DEPARTMENT OF ENVIRONMENTAL QUALITY

RE: FOREST VIEW ADDITION
SANDERS COUNTY
E.Q. #96-2615

STATE OF MONTANA
DEPARTMENT OF ENVIRONMENTAL QUALITY
CERTIFICATE OF SUBDIVISION PLAT APPROVAL
(Section 76-4-101 through 76-4-131, MCA 1993)

THIS IS TO CERTIFY THAT the plans and supplemental information relating to the subdivision known as **Forest View Addition**

FOREST VIEW ADDITION LOT LAYOUT

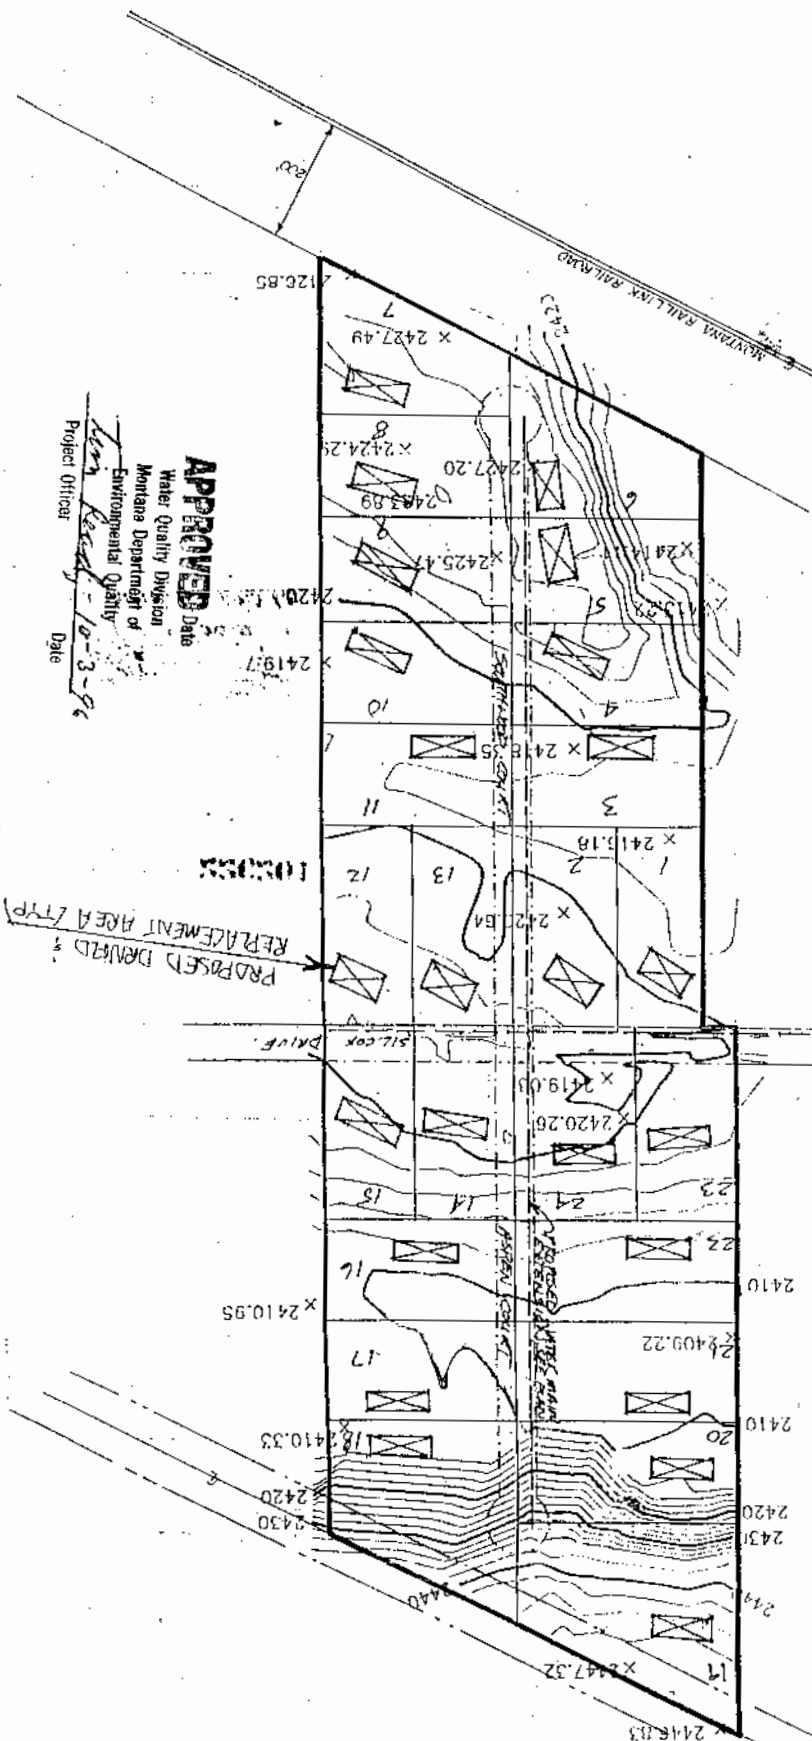
THAT all sanitary facilities must be located as shown on the attached lot layout, and,

THAT the developer and/or owner of record shall provide each purchaser of property with a copy of the plat, approved location of water supply and sewage treatment system as shown on the attached lot layout, and a copy of this document, and,
